Log # TXX-97047
File # 10010
909.5
Ref. # 10CFR50.48

SUBJECT: COMANCHE PEAK STEAM ELECTRIC STATION (CPSES) - UNIT 1
DOCKET NO. 50-445
RESPONSE TO SAFETY EVALUATION OPEN ITEMS ON CPSES
UNIT 1 REGARDING THERMO-LAG CABLE FUNCTIONALITY ISSUES
(TAC NO. M85536)

Reason for Revision 4 : This report is being revised to incorporate responses to the seven open items in the NRC letter dated May 22, 1996, from Mr. Timothy J. Polich to Mr. C. Lance Terry regarding Thermo-Lag installations and fire endurance testing implemented to certify Unit 1 fire barriers. Please refer to Appendix F of this report for details.

APPENDIX F
REVISED RESPONSES TO NRC OPEN ITEMS

Graph of Least-Squares regression for TU Electric Test scheme 13-2, 11-5, and 11-2 data

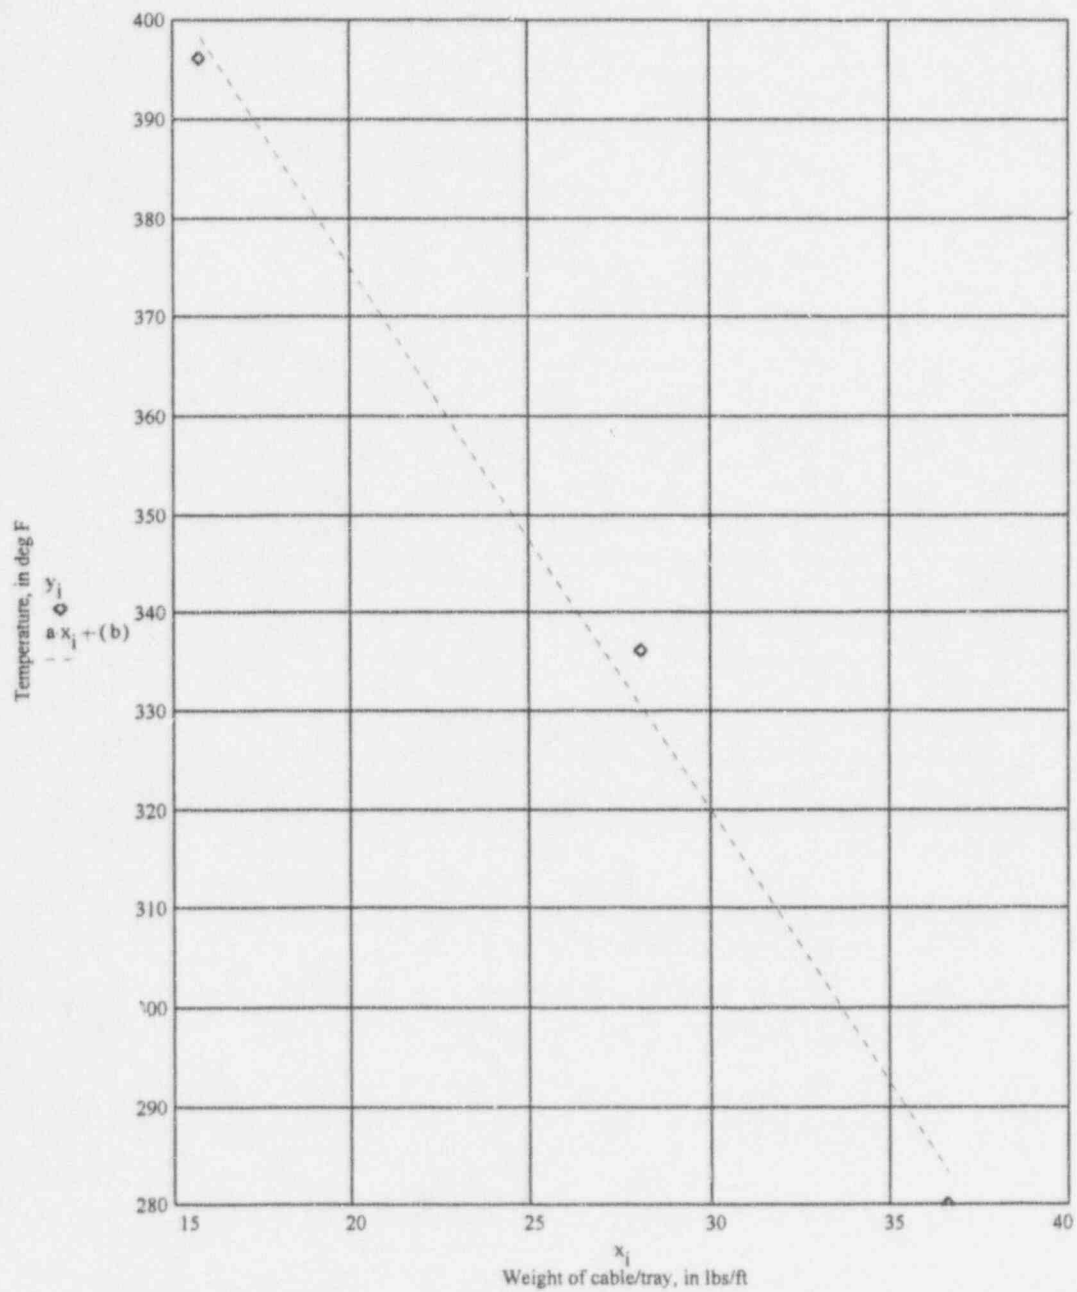
For raceways at CPSES Unit 1, where the total enclosed thermal mass is less than the total enclosed thermal mass of the tested configurations, the test results do not provide an adequate basis for evaluating fire barrier performance. The rating of these barriers (if any) is therefore indeterminate, and these configurations may deviate from the licensee's commitment, in section 9.5.1 of the CPSES Final Safety Analysis Report (FSAR), to provide barriers having a fire resistance rating of 1 hour at CPSES Unit 1.

These temperature values were then incorporated into the equation previously derived to calculate the affects of a change in cable/conduit mass. This analysis is included in Attachment 1 to Appendix F.
